Figure 1. Comparison of Extrapolation Schemes of the Original and Current Dose Rate
Calculations

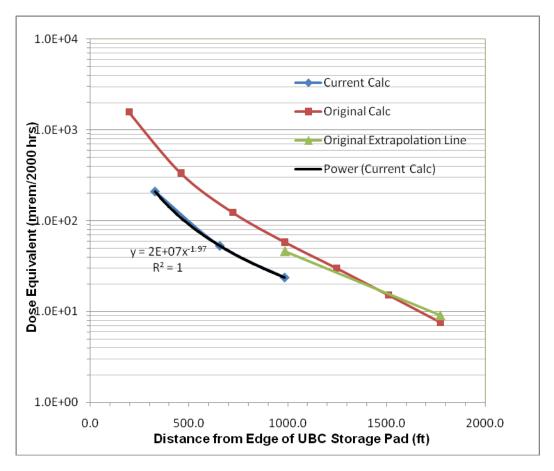
[3] In the revised table 4.12-1, the dose rate to the nearest business appears to have increased by two orders of magnitude (was 10⁻⁵ now 10⁻³). Please explain this change.

ANSWER: Numerous factors contribute to the difference noted in magnitude between the initially estimated dose rate values to the nearest business, located NNW of the site, and the current estimated dose rate values based on the expanded UBC Storage Pad. The <u>original</u> calculation (32-2400507-00) utilized an extrapolation scheme to estimate the dose rate to the nearest business that was based on a composite curve constructed by using the maximum total dose at any given distance from the edge of the pad (from either side). The line used to extrapolate to the nearest business is based on a linear trend/regression type between two points, as illustrated in Figure 1 below. The total dose rate at the nearest business is also estimated based on an extrapolation scheme in the <u>current</u> calculation (CALC-S-00141, Rev. 1) representing the expanded UBC storage pad. The extrapolation scheme is based on the power trend/regression type from three points of the curve representing the total dose rate from the north side of the pad as illustrate in Figure 1 below.

Figure 3. Extrapolation Scheme Used in Current Calculations (CALC-S-00141, Rev. 1) for Dose Estimates in the West Direction of the UBC Storage Pad

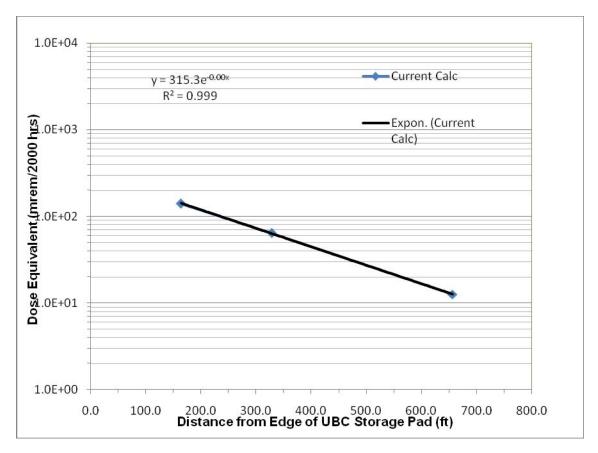
[4] In the revised table 4.12-1, the dose rate to the nearest resident appears to have decreased by a factor of 40. Please explain this change.

ANSWER: The nearest resident is located in the west direction of the site. The original calculation (32-2400507-00) utilized the composite curve (based on the maximum dose rates

at any given distance from the edge of the pad illustrated in Figure 1) to extrapolate the dose rate value at the nearest resident location. In the current calculation (CALC-S-00141, Rev. 1), the extrapolated dose rate values are based on the west side (e.g., short side) of the UBC Storage Pad per extrapolation scheme shown in Figure 3.

It must be emphasized that the value presented in Table 4.12-1 was mistakenly based on the 1.17 mile distance (representing the nearest business) and not the 2.63 mile distance to the nearest resident. When adjusted, it was noted that the estimated dose rate based on the 2.63 mile distance and full-time occupancy (8760 hours) reduced significantly, as expected, to a value on the order of <4.0 E-27 mrem/yr. The public and the nearest resident, the value in Table 4.12-1 has been updated to reflect the dose rate estimate based on the dose profile.
